PLANNING DIVISION REPORT
DEPARTMENT OF PLANNING AND COMMUNITY
AND ECONOMIC DEVELOPMENT
October 17, 2008

RE: I.D. # 11935: Zoning Map Amendment LD. 3388, Rezoning of 718 South Orchard Street from PUD-SIP to amended PUD-SIP

DATE: September 26, 2008
TO: Plan Commission
FROM: Larry D. Nelson, P.E., City Engineer
SUBJECT: 718 South Orchard Street Rezoning

Southern view from rear yard of 710 S. Orchard St. (two lots north of subject property)

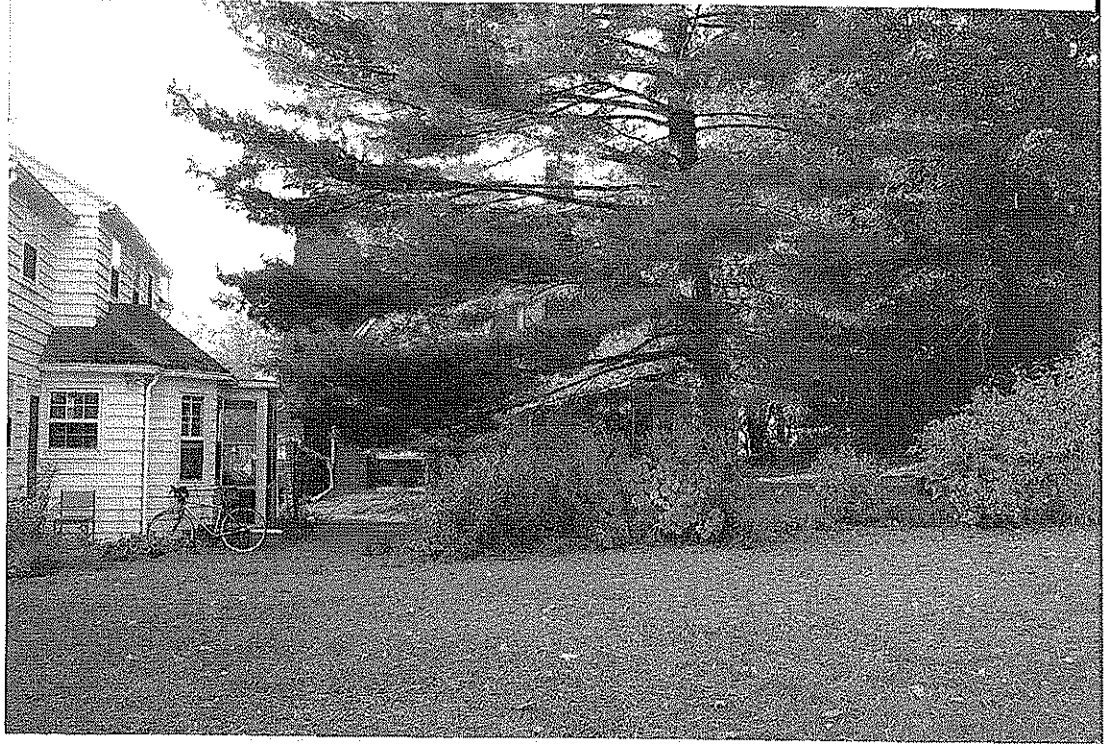
Third, Planning Division staff has determined that the most significant impacts from the proposed additions may be felt by current and future residents in the property immediately to the north. With a rear yard setback of over 45 feet, residents have at least partial views of Henry Vilas Park and Lake Wingra from their backyard. While the proposed two-story addition to the northwest portion of the building would form a consistent line along the rear of the building, it would appear as quite a significant change from the north, blocking much of the winter view toward Lake Wingra. The proposed additions to the northwestern portion of the building are essentially occurring in what would be a required rear yard under R3 zoning, which applies to all of the properties to the north.
